**Response by  
Australian Network for  
Universal Housing Design  
to the  
Draft National Construction Code  
2022**

29 June 2021

1.2 Parking space incorporated into step-free access path

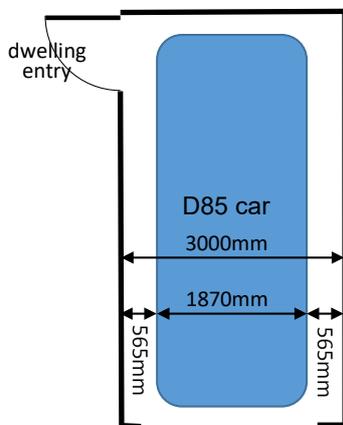
- Clause 1.2 does not take into account the requirement of Clause 2.3 (1), as follows:
  1. An entrance door that is subject to Clause 2.1 must have a space of at least 1200 mm x 1200 mm on the external (arrival) side of the door that is—
    - a. unobstructed; and
    - b. level, or has a gradient not exceeding 1:40 if a gradient is necessary to allow for drainage.
- Using AS/NZS 2890.1:2004, which references a D85 (1870 mm wide) vehicle and specifies a minimum width of a single car garage as being 3000 mm, it is calculated that the minimum acceptable width for a vehicle door opening on each side of the vehicle is 565 mm.

- Using the draft ABCB LHD standard, and the above D85 (1870 mm wide) vehicle size and 565 mm vehicle door opening on one side (being the side of the vehicle on which a person without a mobility-related disability is sitting), there is inadequate space on the other side of the vehicle (being the side on which the person with a mobility-related disability is sitting) for a 1000 mm wide step-free path of travel to the entry.
- A single vehicle garage must be at least 3435 mm wide to fully comply with the draft ABCB LHD standard. See the diagrams below.

- 1 Where one or more car parking spaces are connected to or form part of a required access path, at least one of the car parking spaces must have—
  - a. a minimum unobstructed space of 3435 mm wide x 5400 mm long.

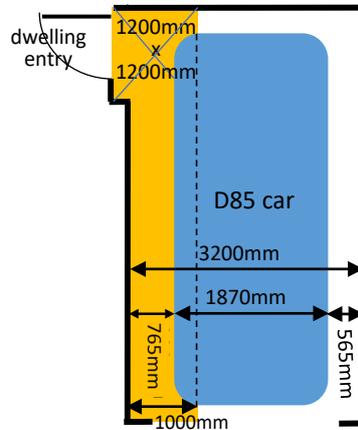
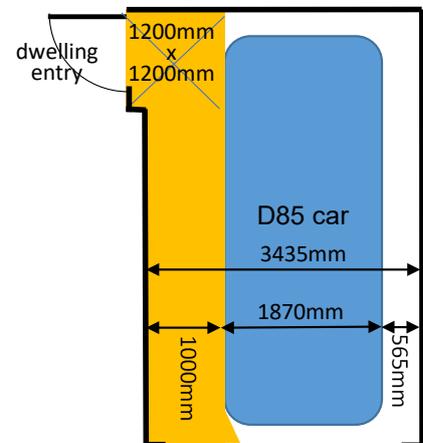
565 mm is acceptable minimum for able-bodied person to exit a vehicle

565 mm for able-bodied person to exit the vehicle

1000 mm step-free path of travel to dwelling entry

565 mm for an able-bodied person to exit a vehicle

1000 mm for a person with mobility-related disability to exit a vehicle

- Note: As a vehicle may be driven into the garage either forwards or backwards to allow a person with a *mobility-related disability* to exit the vehicle and travel to the dwelling entrance, the path of travel on each side of the vehicle will need to be unobstructed.

**Clause/Figure/Table:** Figure 6.2d

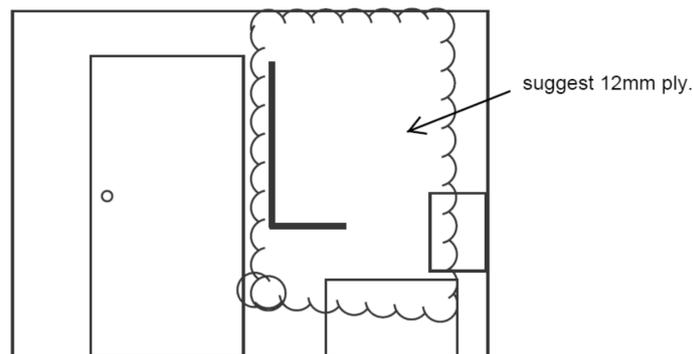
- This appears to be an error in the draft. (See LHDG version 4 (p. 41)) for correct measurements.)

Figure 6.2d should show the total height of the sheeting as 1850 mm above the shower floor.
